**Consultation Response from KC,
Lead Local Flood Authority**

2024/93605 Land at, Main Avenue, Cowlersley, Huddersfield, HD4 5US

Erection of 57 dwellings with access from new through road connecting Main Avenue and Windsor Road, and associated works, including engineering and landscaping

Date Responded: 7th February 2025

warneford road

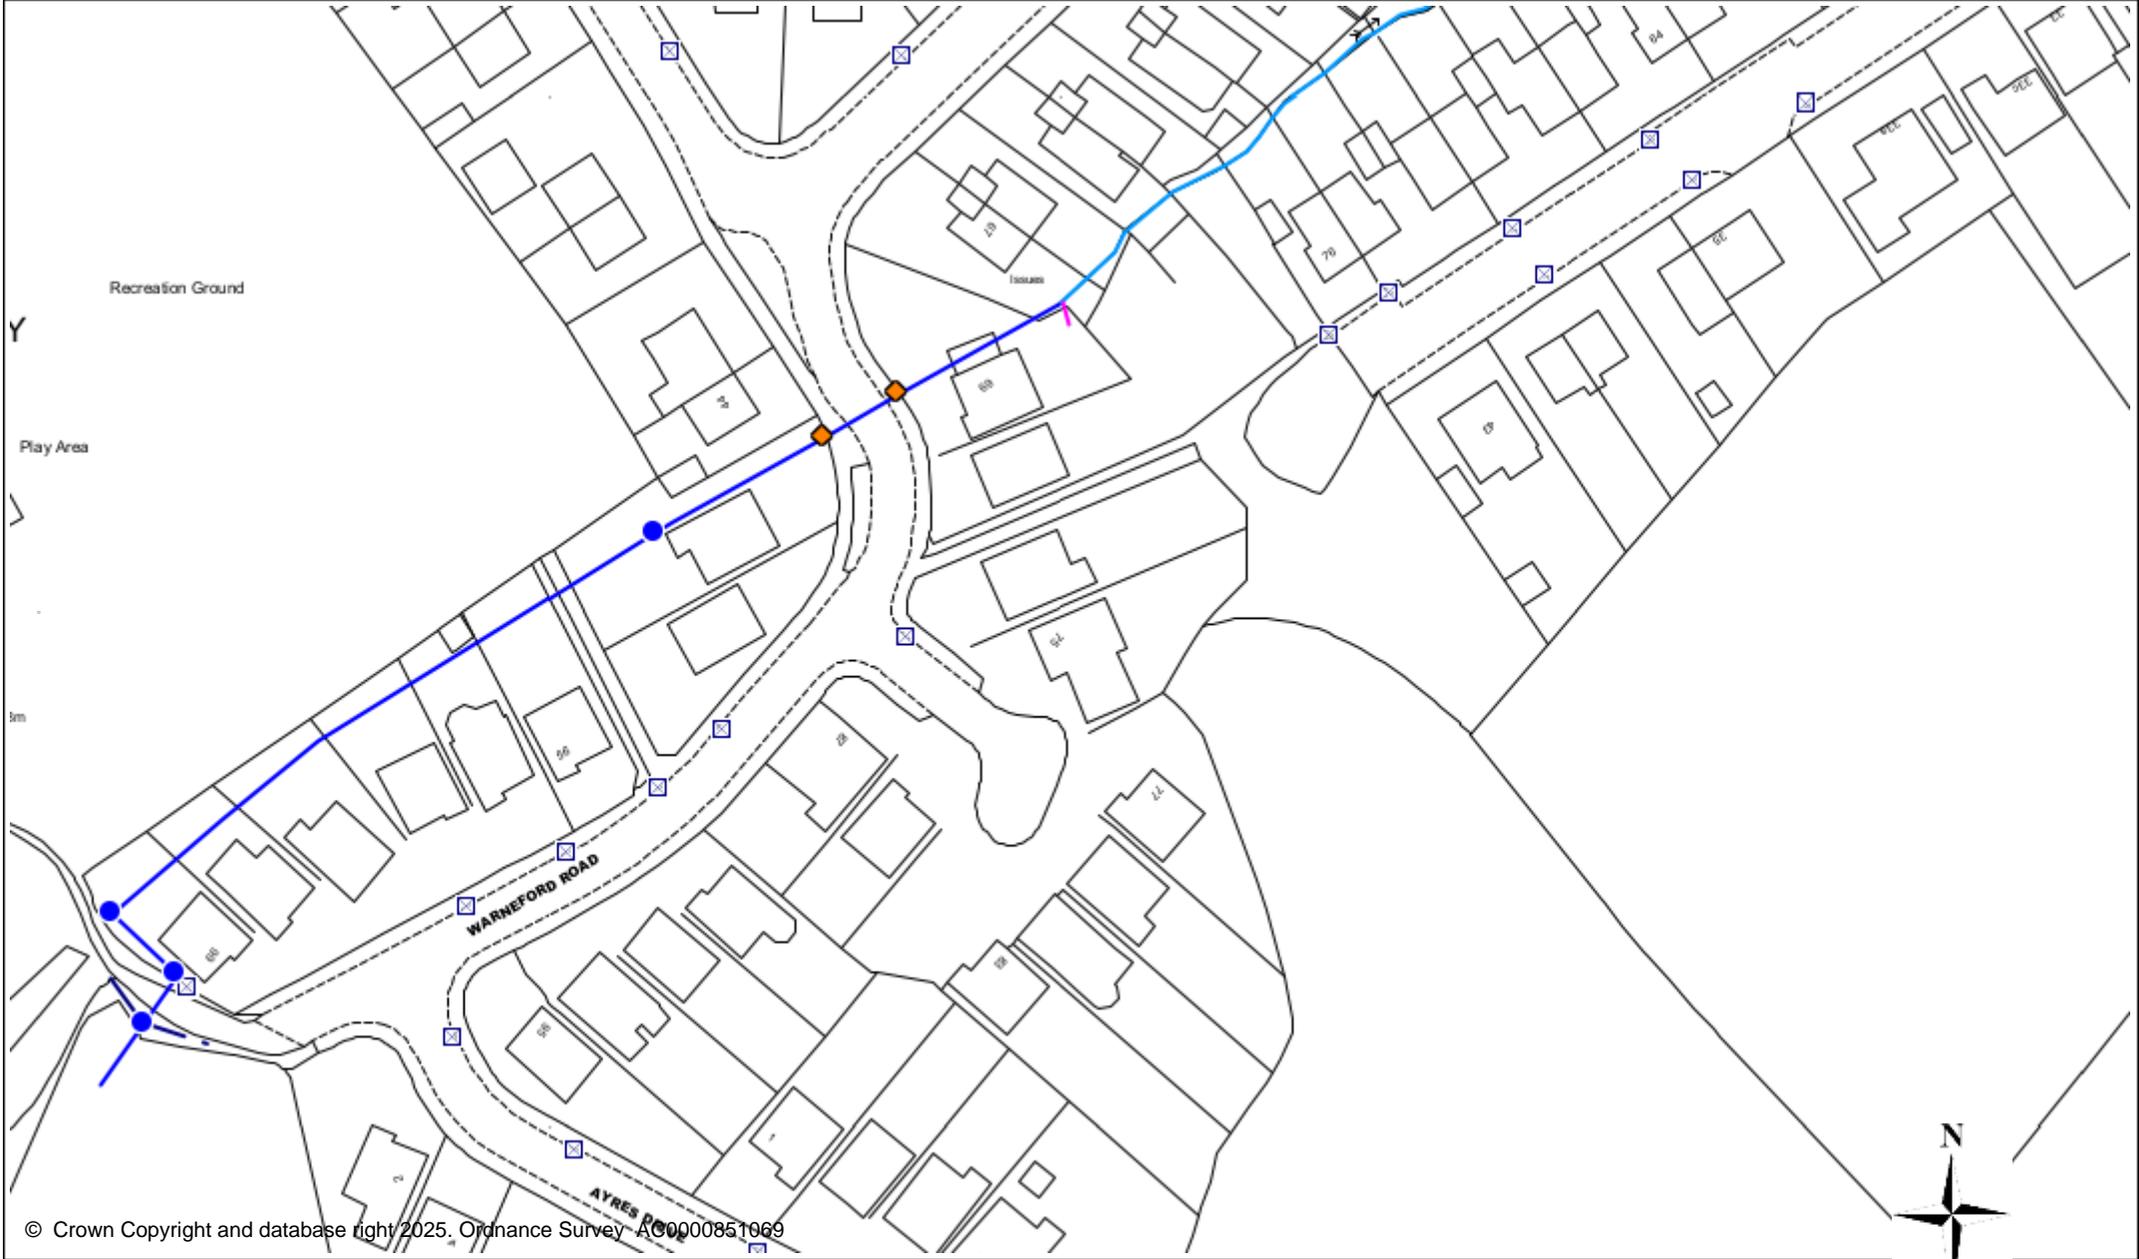
We note that a survey of the watercourse running from site at the eastern boundary has been attempted indicating some capped off land drainage but with the main run obstructed. As land drainage from the site will need to connect in at this point, a full downstream survey of the culverted section of the watercourse is required to show that it is fit for purpose (this will form part of the flood risk assessment). For a site of this size, the survey should extend to the first open section located at 67 Warneford Road (see attached).
